23029-01-001

Proposed Extension to Educate Together School at Esker, Lucan, Co. Dublin

ROAD SAFETY AUDIT STAGE 1/2

April 2023

2.3 Observation

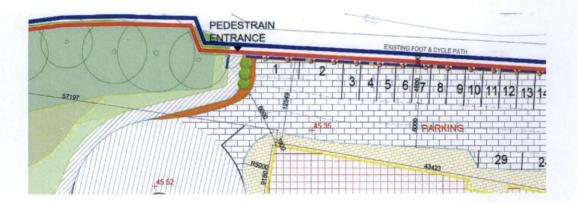
There would appear to be a relatively large catchment within walking distance of the school – the surrounding area is almost entirely residential. A pedestrian gate is being retained that connects the school to Esker Meadow View and that will be beneficial to road safety in terms of providing increased permeability and promotion of active travel. Through ongoing mobility planning, the school should seek to improve the safety and directness of walking routes to school. For example, maximising

pedestrian connectivity through the sites of adjacent schools would be beneficial, as would improvements to pedestrian permeability in housing estates (such as Esker Lodge and Elmbrook Walk – see image below)
